Item No. 18 Town of Atherton

**SUBJECT: RECEIVE CIVIC CENTER PROJECT UPDATE; REVIEW,
DISCUSS AND PROVIDE DIRECTION ON DESIGN CHANGES
AND VALUE ENGINEERING OPTIONS FOR THE LIBRARY;
AND REVIEW, DISCUSS AND PROVIDE DIRECTION ON
FUNDING ISSUES RELATED TO THE OVERALL PROJECT**

PMC Library VE Meeting Minutes: Meeting No 1

Attachment

OPTION 1

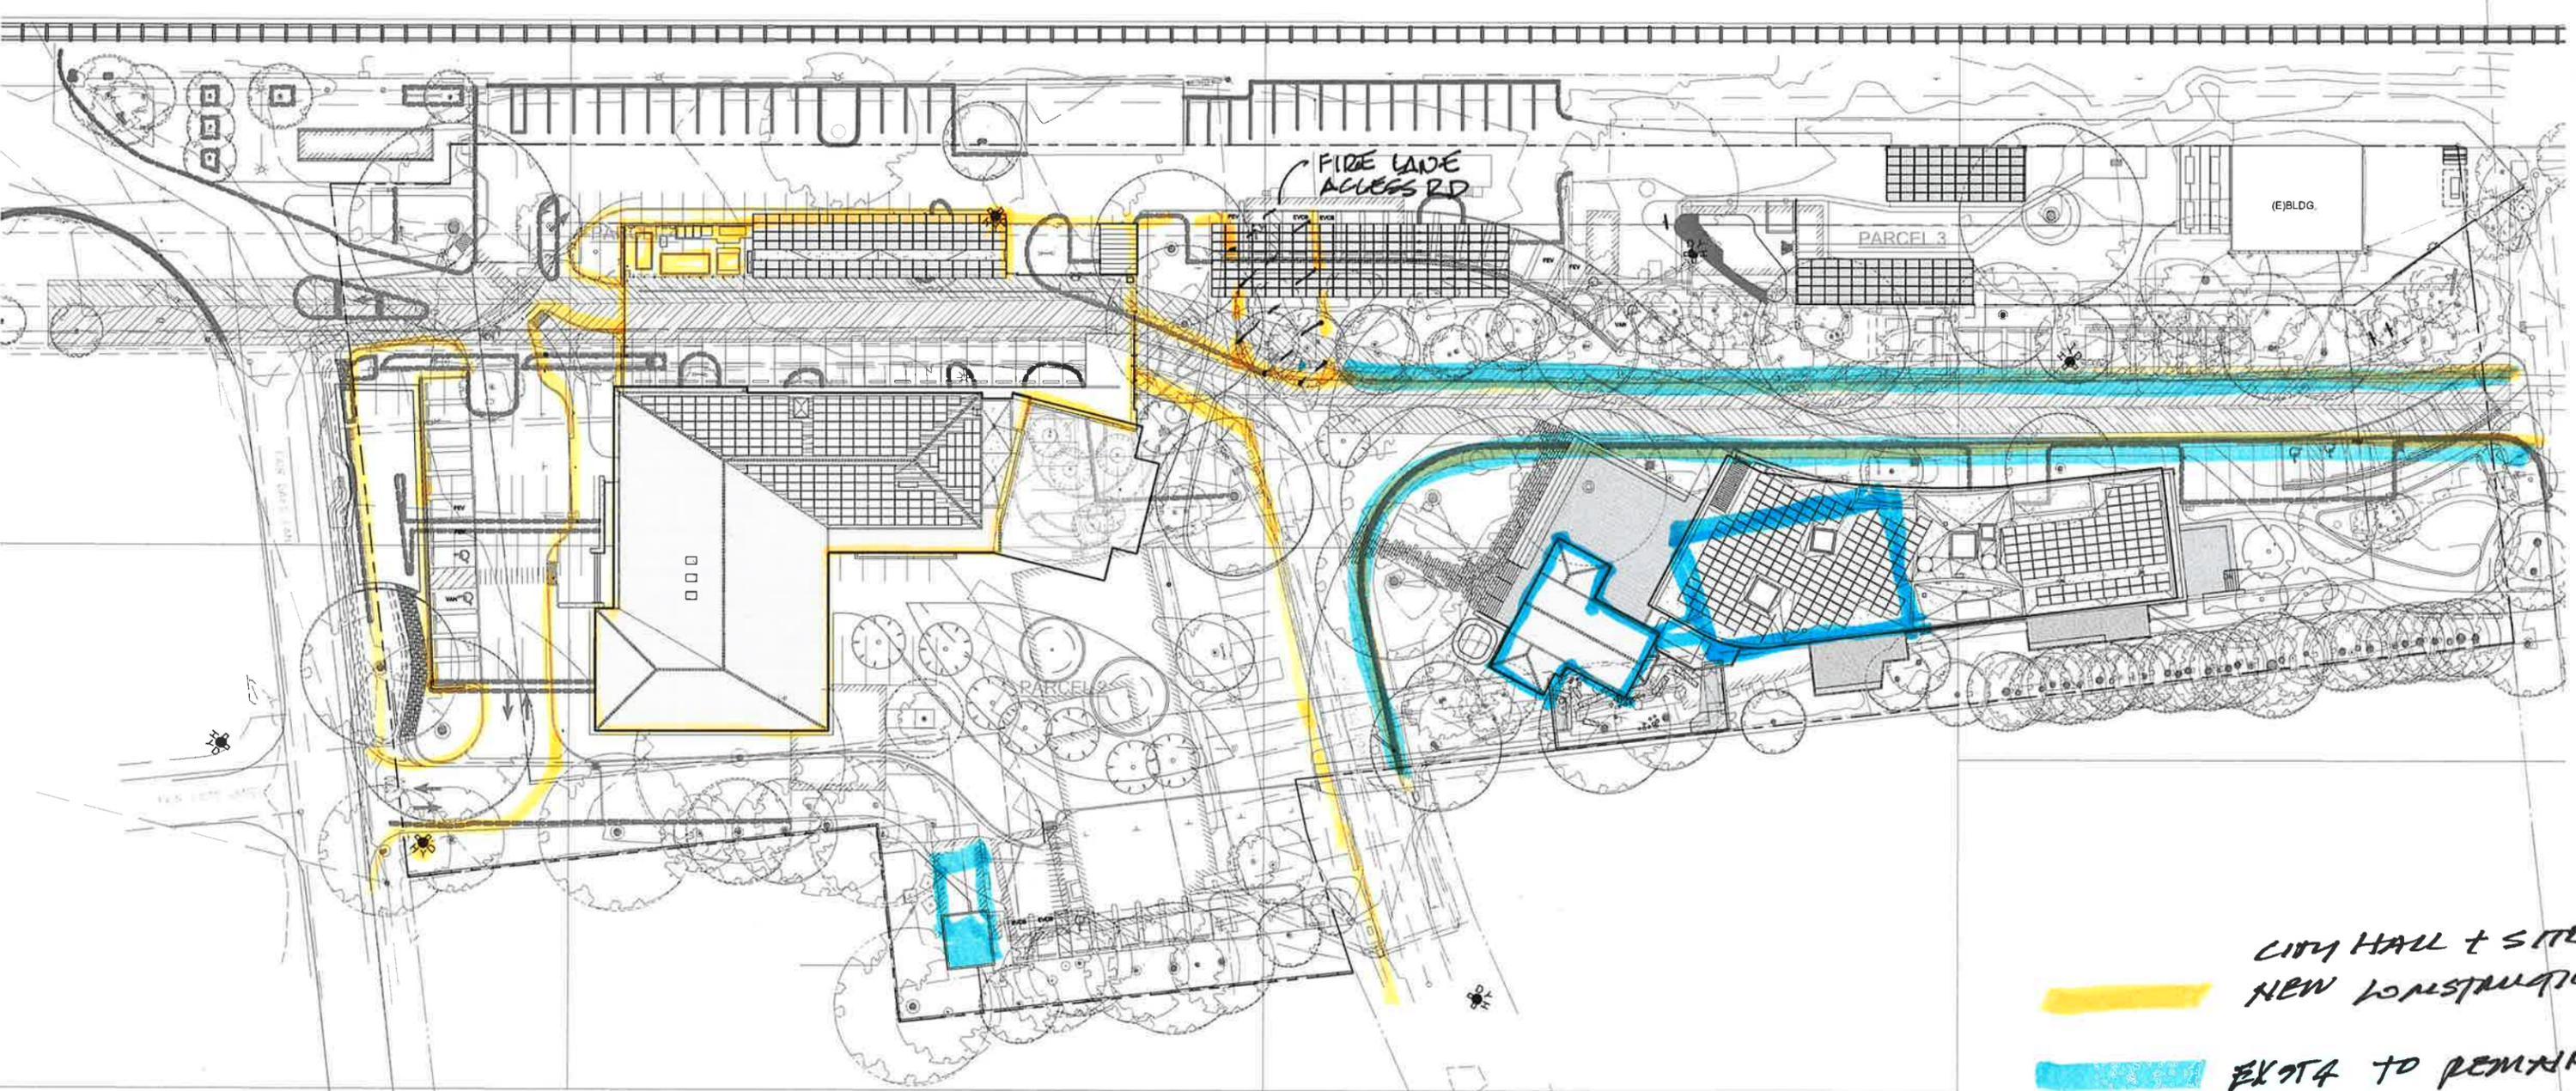
NO EMER. GENERATOR
NO MICROGRID

EXSTA TO REMAIN.

SMALLER HEAT PUMP

PARTIAL SITE WORK,
LIBRARY & BLEC.

EXSTA TO REMAIN.

OPTION 2.

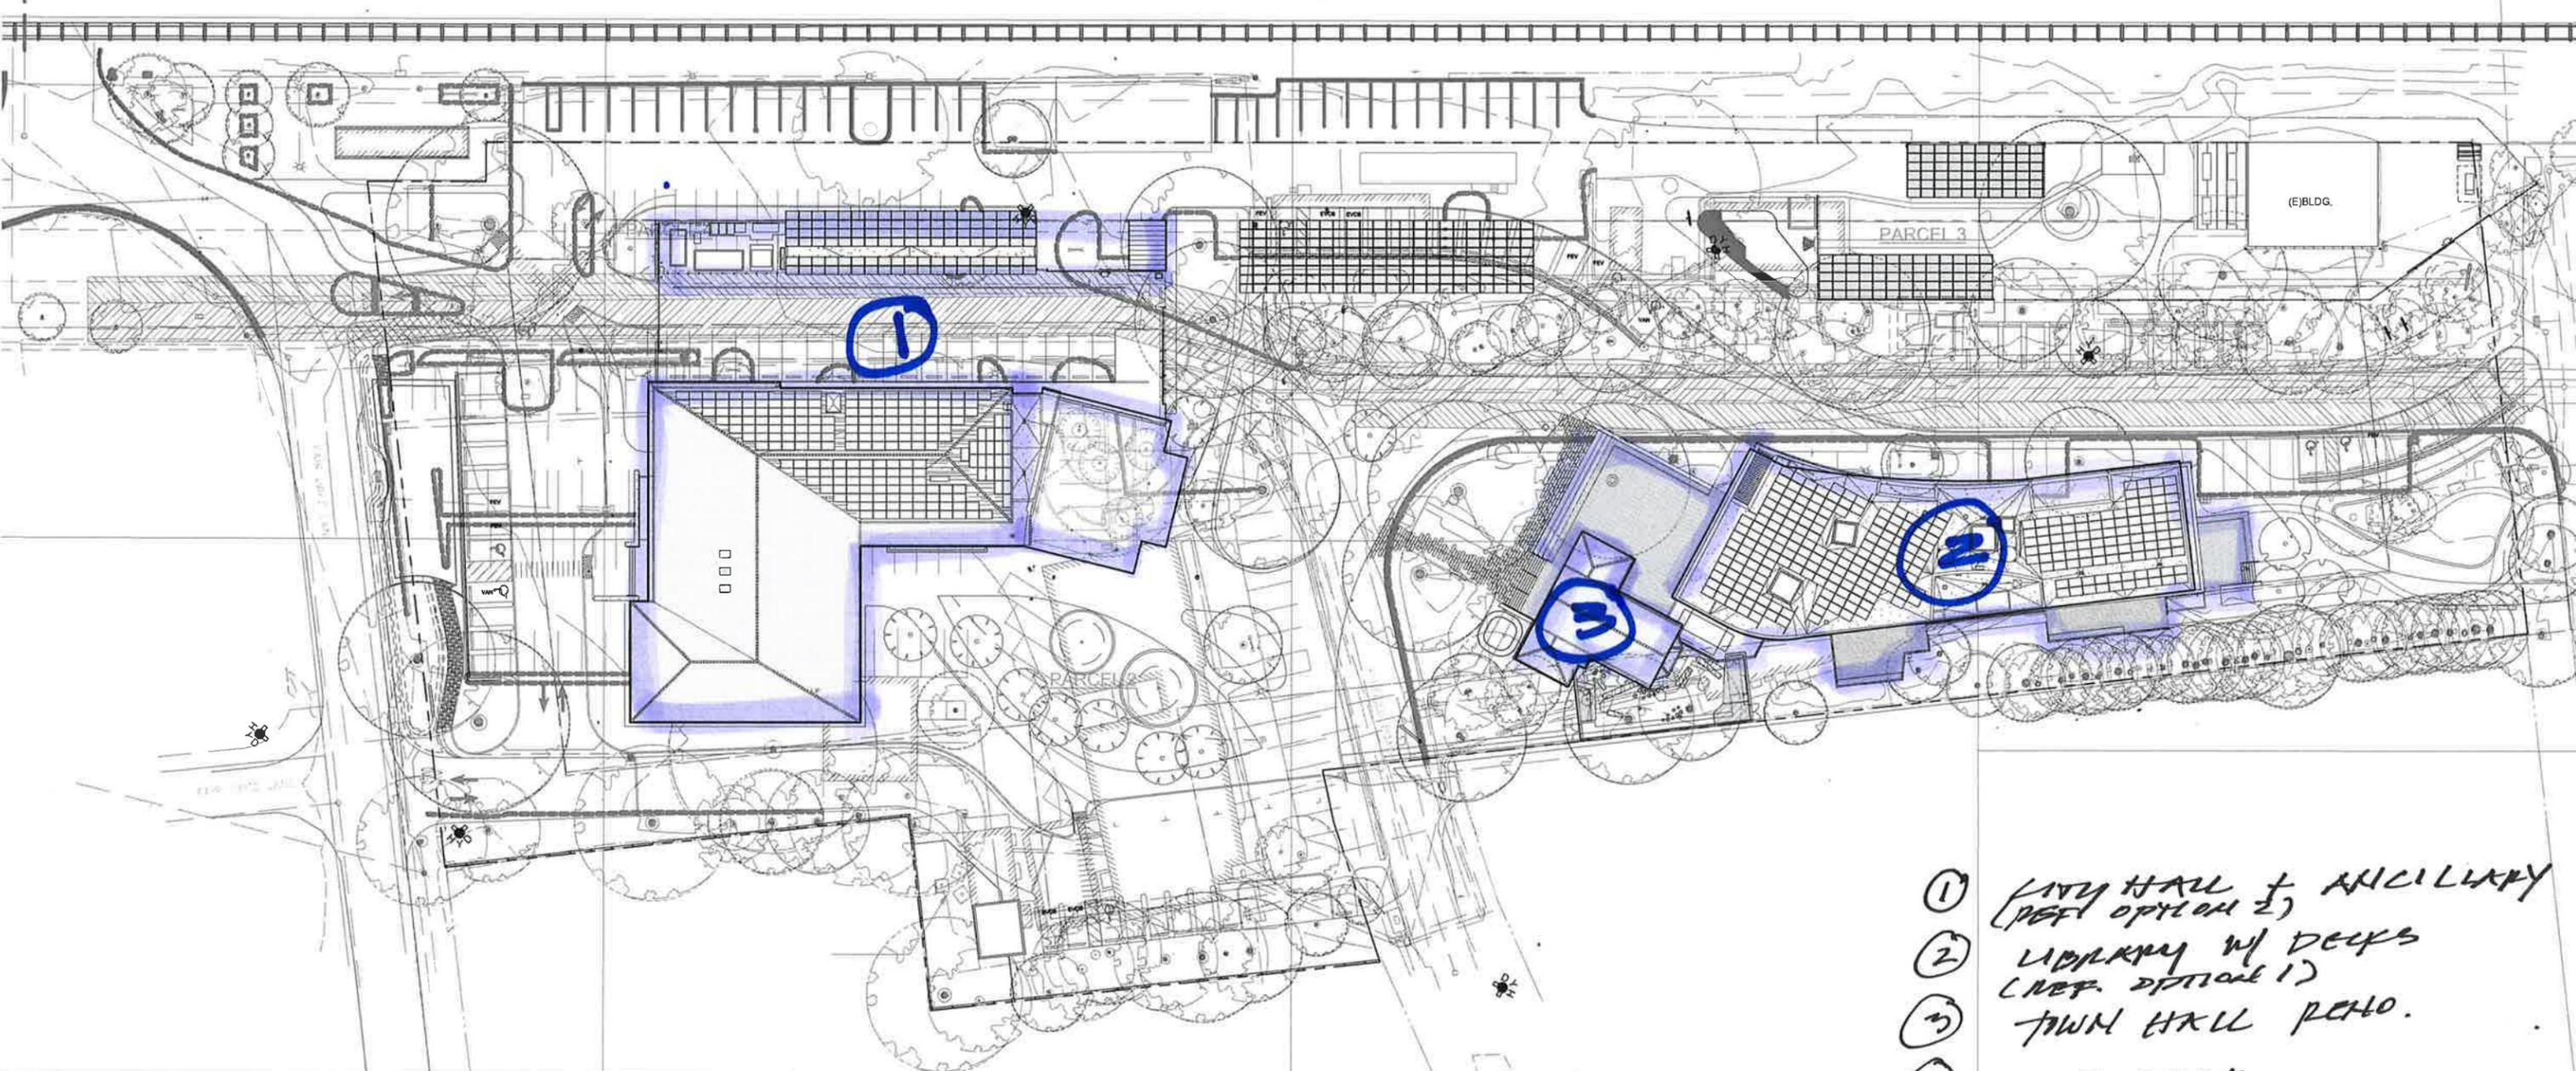
CITY HALL + SITE,
NEW CONSTRUCTION

EXIST TO REMAIN

OPTION 2

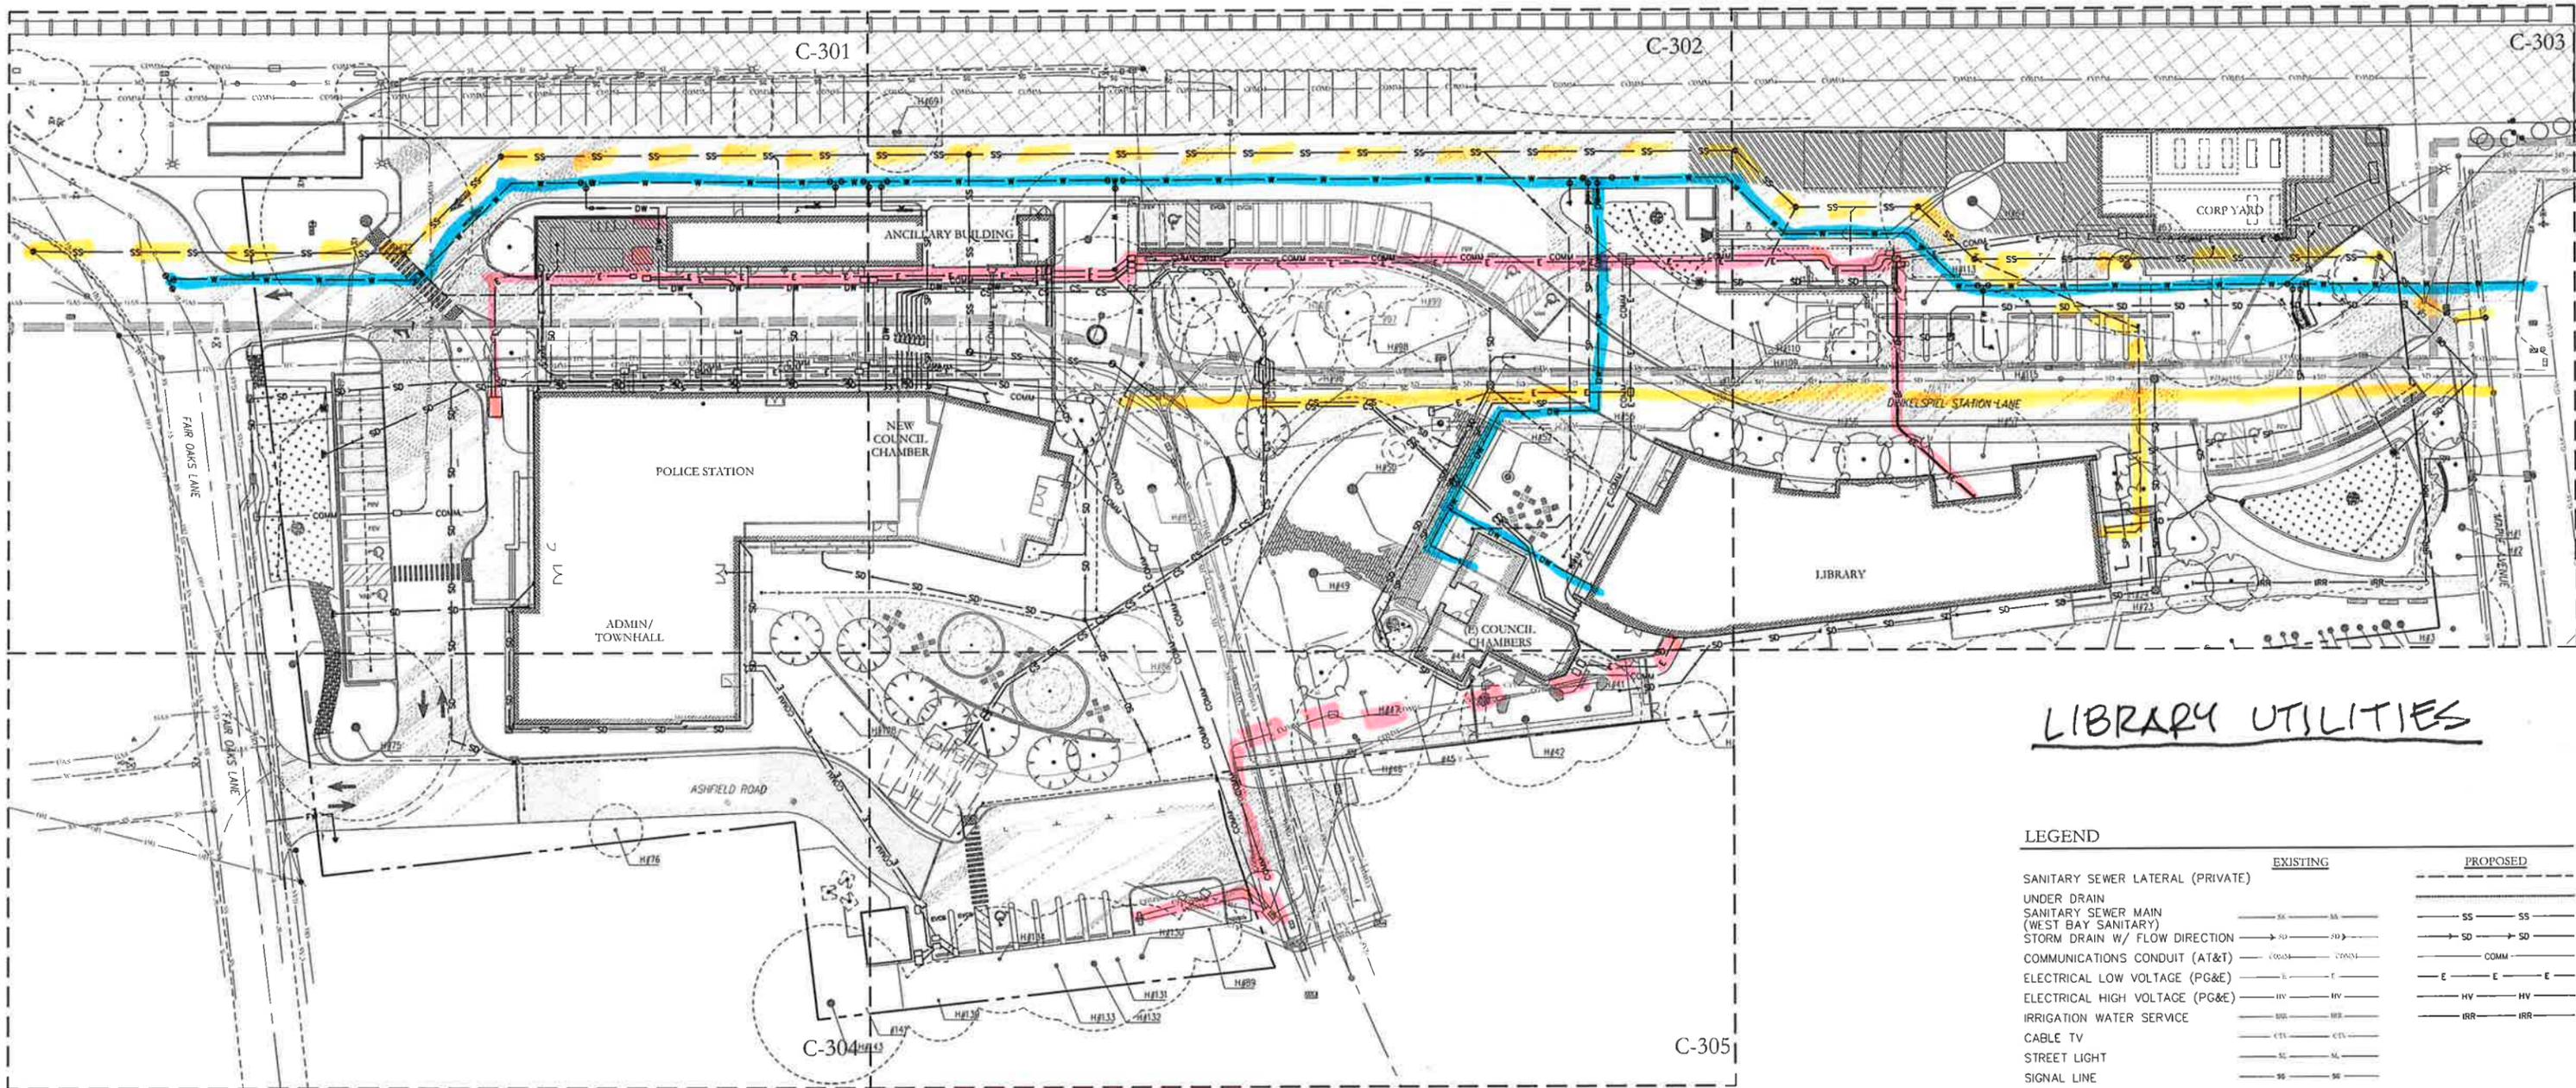
- ① CITY HALL + ANCILLARY
(REF. OPTION 2)
- ② LIBRARY w/ DECKS
(REF. OPTION 1)
- ③ TOWN HALL PERHO.
- ④ SITE WORK

LIBRARY UTILITIES

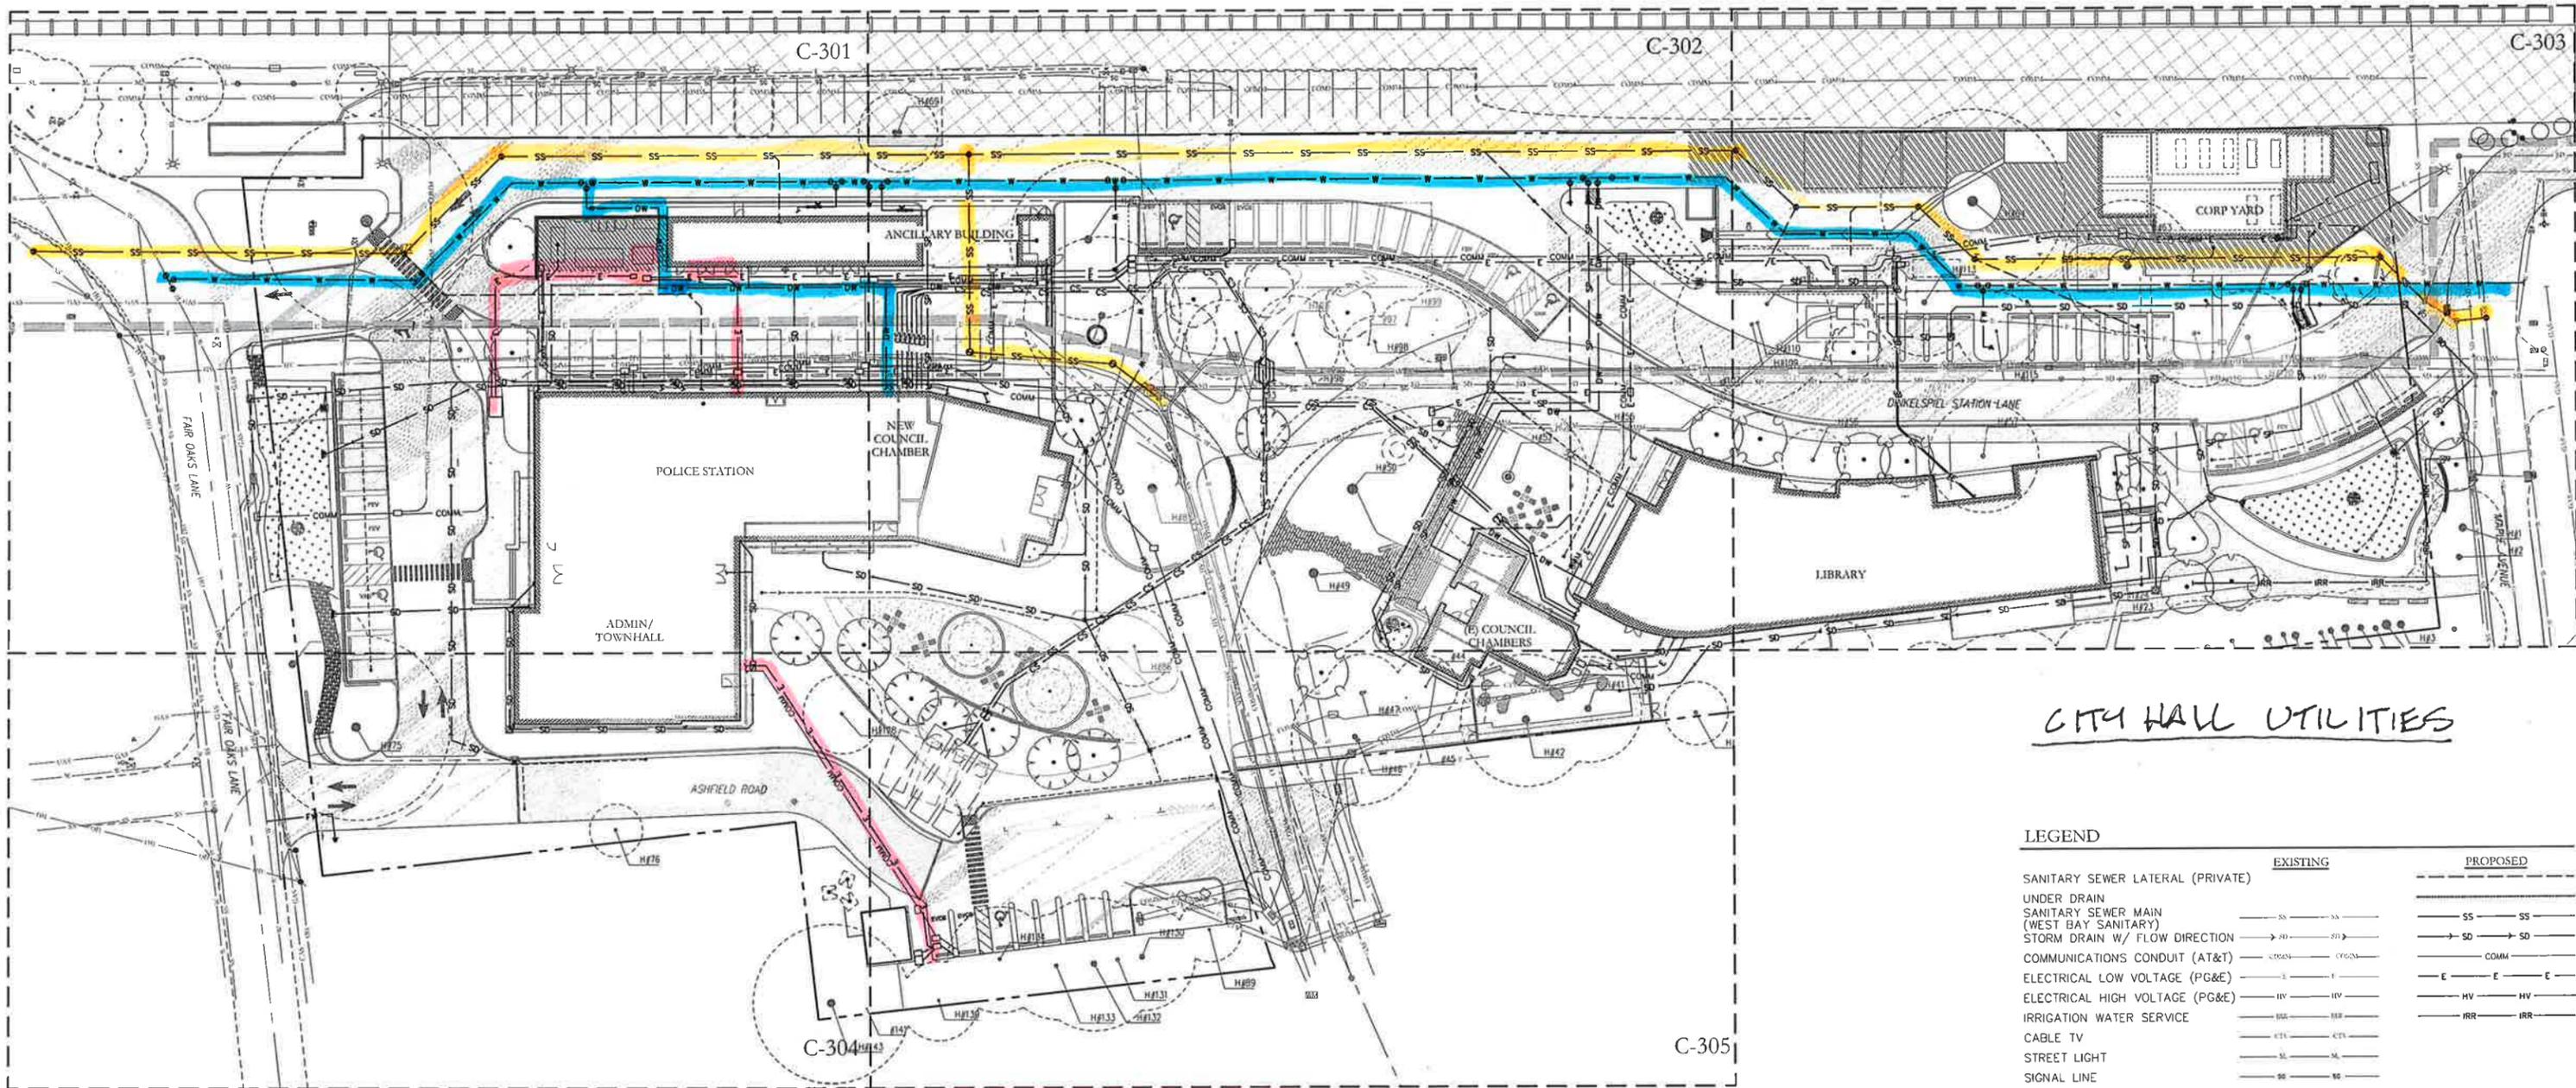
NEW SITE ELEC. OPT.
 (E) ELEC. SERV (MUST BE STUDIED)
 NEW SITE WATER
 (E) SANITARY SEWER
 OPTIONAL SAN. SEWER (DEMO EXIST LINE)
